Response to Submissions Report – Detailed SSDA

Crows Nest Over Station Development
Detailed SSDA 75660711

32 Hume Street, Crows Nest

7 November 2025

Figure 1 Page 80 Design Report (Appendix H) (Source: Woods Bagot)

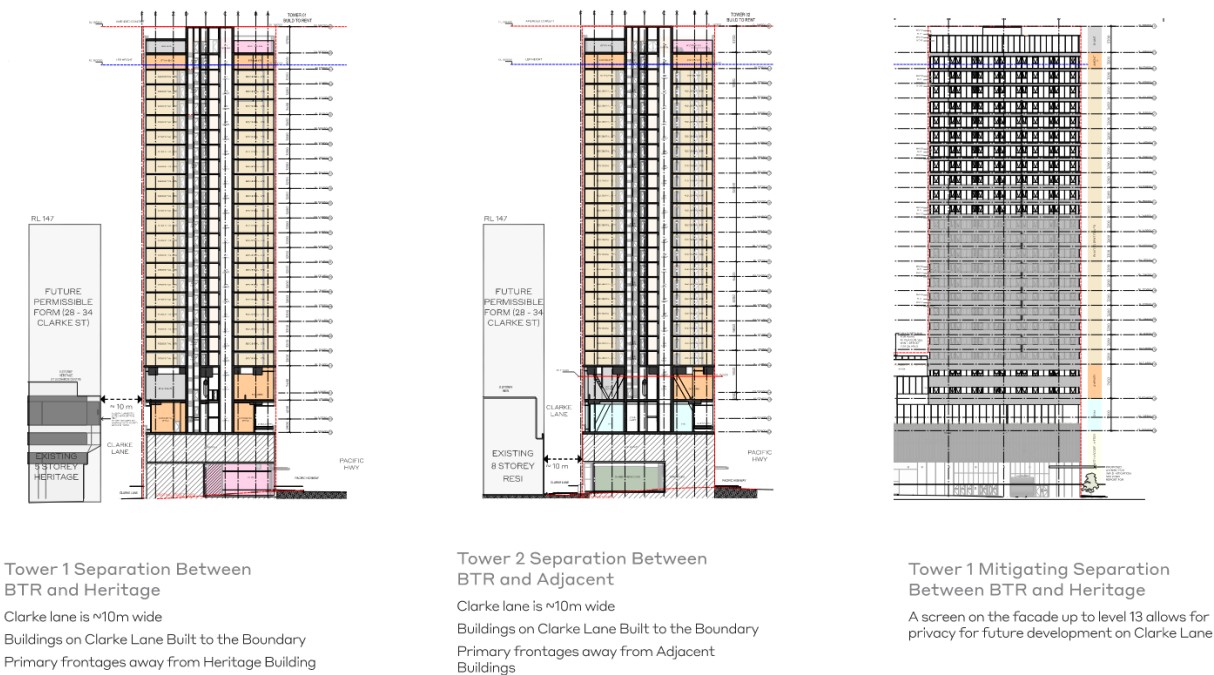
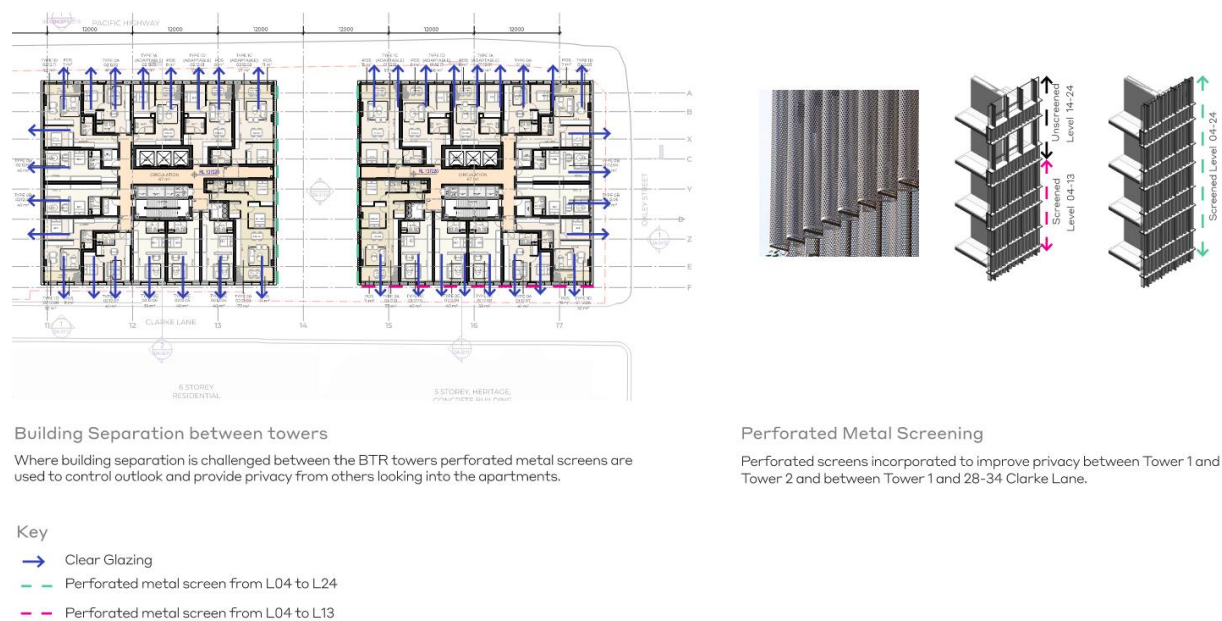
Issue	Response	Relevant Report(s) / Plan
1 Amenity		
a) Review and reconsider the proposed building separation between the BTR towers to: i. maintain a reasonable level of privacy between the proposed apartments	i. As will be appreciated, the proposed detailed built form has been located and designed on top of the existing Metro Box, with the towers distributed to correspond directly to structural advice. This has been a primary driver in establishing the building separation between the towers on the site and with future towers on surrounding sites. The initial residential envelope followed by proposed detailed building form was the by-product of the feedback provided during the initial and subsequent State Design Review Panel (SDRP) meetings with Government Architect NSW (GANSW). Multiple massing schemes were developed by Woods Bagot during the pre SSDA submission design development stage with GANSW to determine the most appropriate distribution of height and mass for the BTR towers given the constraints of the site being atop the Metro Box. As noted in the SDRP Minutes provided in the original Detailed SSDA (Appendix 23), it is shown that the proposed built form was supported during all three meetings with the SDRP. In light of the concurrently proposed amendments, the building separation distances which afford privacy, have been maintained. The revised detailed design of Towers 1 and 2 mean the residential floor plates are now mirrors of one another. Crucially, the primary living rooms and private open space (wintergardens) are oriented north and south—facing outward (to Pacific Highway or Clarke Lane) rather than toward each other. Where towers do face internally, interfaces consist only	Architectural Plan Set – Appendix G

Issue	Response	Relevant Report(s) / Plan
ii. improve solar access to the proposed apartments	of secondary living room windows and bedroom windows. These windows are proposed to be treated with perforated metal screen from level 4 to level 24, see the green dash below.  Building Separation between towers Where building separation is challenged between the BTR towers perforated metal screens are used to control outlook and provide privacy from others looking into the apartments. Key → Clear Glazing — Perforated metal screen from L04 to L24 — Perforated metal screen from L04 to L13 The landowner of 28- 34 Clarke Street reasonably raised a particular concern regarding the separation distances on the Clarke Lane elevation and a future proposal on their site. In a meeting with the adjoining landowner, they recognised the constraints of the metro-box and how this has driven the separation distances. They were comfortable with the introduction of privacy mitigation measures to aid in ameliorating privacy impacts. The privacy measures detailed on page 80 and 81 of Woods Bagot's Design Report (Appendix H) have been implemented on the architectural plans to achieve reasonable levels of privacy. Refer to section 3.6.2 of this RtS Report.

Issue	Response	Relevant Report(s) / Plan
iii. reduce reliance on mitigating measures such as fixed windows and tinted glass, which are likely to compromise other amenity aspects, including light, outlook, and ventilation.	converting level 24 on both towers from residential to communal indoor space (and deleting previously proposed level 25). The level 24 amenity spaces will feature multi-purpose programming including media, lounge, private dining and co-working spaces. These spaces are attractive for resident renters who may prioritise location and smaller private space for compensatory features, such as shared facilities (Appendix N). The delivery of high-quality communal indoor space at level 24 and the rooftop communal open space, creates a diverse range of weather-protected and environmentally controlled amenities to support social interaction, recreation, and relaxation. An additional site constraint limiting solar access is that the north-facing frontage (Oxley Street) is only 29m long, while the southwest-facing Pacific Highway frontage is nearly four times longer. To counteract this attribute, the towers are broken into 3 distinct masses, creating slots between them that allow sunlight to filter through. Despite these efforts, the site's constraints remain a limiting factor in achieving full compliance. However, the design prioritises solar access wherever possible while maintaining a high level of residential amenity through a combination of orientation strategies, dual-aspect apartments, and high-quality communal spaces and suitable apartment size and mix for the BTR and affordable housing market. Majority of the Tower 1 and Tower 2 façade do not require privacy measures. Perforated metal screens are proposed as privacy measures on the following facades: - On the internal façade of Towers 1 and 2 on level 4-24 inclusive - On the eastern elevation (Clarke Street) of Tower 1 on level 4 to 13 – corresponding to a future permissible built form on the adjoining site of 28- 34 Clarke Street Refer to pages 80 and 81 of the Design Report (Appendix H) for further detail.

In response to their queries, Woods Bagot have introduced a perforated metal screen on the eastern elevation (Clarke Street) across level 04 to level 13 façade Tower 1 at Site A. Levels 4- 13 consider a permissible future development outcome at the adjoining site 28- 34 Clarke Street, see the below figures which are extracts of pages 80 and 81 of Woods Bagot's Design Report (Appendix H).

Issue	Response	Relevant Report(s) / Plan
	ii. A key site constraint is the building's southwest-facing façade which extends approximately 116m in length. Given the requirement to situate the built form above the confines of the Metro Box envelope, strict adherence to the solar access targets is not feasible as the buildings orientation limits direct sunlight penetration. Notwithstanding the above, the amendments to the layout of apartments within the typical floorplates of Towers 1 and 2 has sought to maximise the number of north-facing and dual-aspect units to optimise daylight access and ventilation. In light of the amendments as detailed in the Amendment Report, the overall solar calculation has marginally improved from the original 55% to 56% of apartments. This has eventuated from creating mirrored floorplates of Towers 1 and 2 and providing additional studio and 1-bedroom units. These amendments have enabled the increase of units receiving solar access across the development. In Tower 1, the number of units receiving solar access has increased from 8 to 9 units. In Tower 2, this has increased from 5 to 6 units. The justification for re-cutting the mix of units was driven by research undertaken by Franklin St (Appendix N) that identified a shortfall in the market for studios and 1-bedroom rental units in the area, inconsistent with demand. This is detailed in the Amendment Report. Furthermore, the development aligns with DPHI's BTR Housing and Flexibility Design Guidelines (BTR Guidelines), which recognise that achieving full solar compliance in high-density settings can be challenging. The BTR Guidelines note that developers can provide more communal outdoor spaces or sunny areas throughout the development to provide the solar and daylight benefits. Consistent with the DPHI methodology of applying flexibility, the amendment has sought to increase the amenity for all units, where the buildings orientation precludes greater individual solar access. This has been achieved by the provision of 1,380sqm (2 x whole floors – one in BTR tower 1 and one in BTR tower 2) dedicated to residential amenity through

Figure 3 Amended level 3 bicycle storage (Source: Woods Bagot)

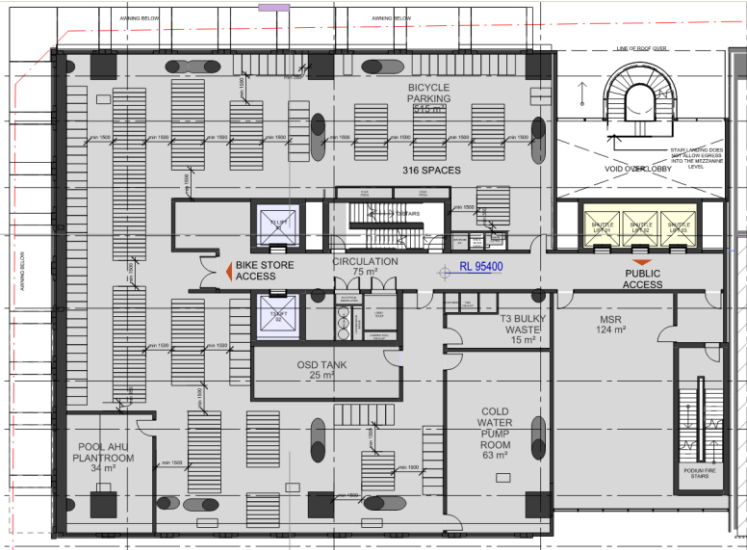
5. Bicycle and end-of-trip facilities should be provided in accordance with the North Sydney DCP 2013.	In accordance with the North Sydney DCP, an additional 306 bicycle parking spaces have been provided to accommodate the increase in unit numbers. The project provides 316 bicycle spaces on Level 1 of Tower 3, 92 spaces on Level 2 of Tower 1/2 and 206 spaces on Level 3 of Tower 1/2. Woods Bagot has clarified access to the bicycle storage areas in the two respective towers.	Architectural Plan DA-2211 and DA-2212 (Rev B) – Appendix G

6. Off-street bicycle parking should be made available for workers of retail and business premises in the development.	Off-street bicycle parking has been made available for workers of retail and business premises. The Level 2 and mezzanine bicycle parking show in Figure 4 and Figure 5 above is accessible to via the Goods Lifts, accessible from Clarke Lane and the Building 3 lobby.	Architectural Plan DA-2200, DA-2211 and DA-2212 (Rev B) – Appendix G
